Local Planning Panel 15 April 2020

21C Billyard Avenue, Elizabeth Bay

D/2019/665

alterations and additions to an existing residential flat building comprising an additional storey containing a new living space and outdoor terrace to unit 11

proposed additional level

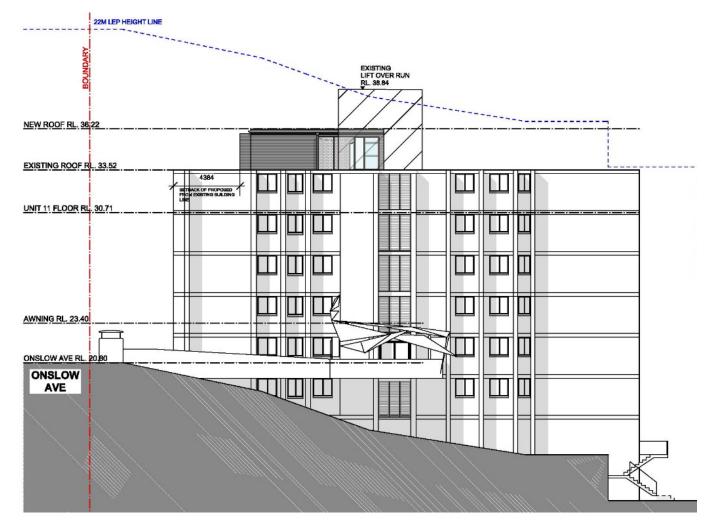
- complies with numerical height control
- no view impact assessment or 3D digital model submitted to assess view loss
- additional information requested but not provided
- unclear if proposal meets building height and design excellence objectives for view sharing

- addition setback 10m from Onslow Avenue
- building retains 5 storey presentation to street due to setback
- middle of building increased to 7 storeys
- acceptable streetscape
- unclear if 7 storeys is acceptable from a view sharing perspective

proposed south elevation

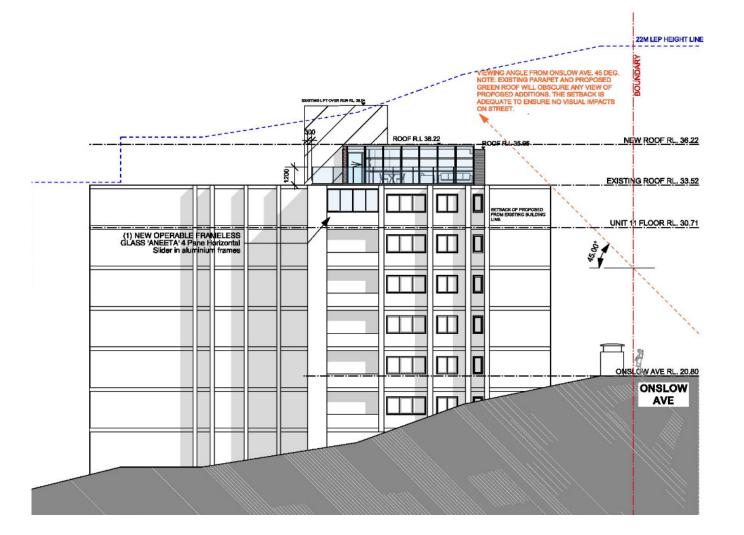
- additional overshadowing of windows on adjoining property to the south
- overshadowing will not impact living rooms or private open space
- overshadowing acceptable
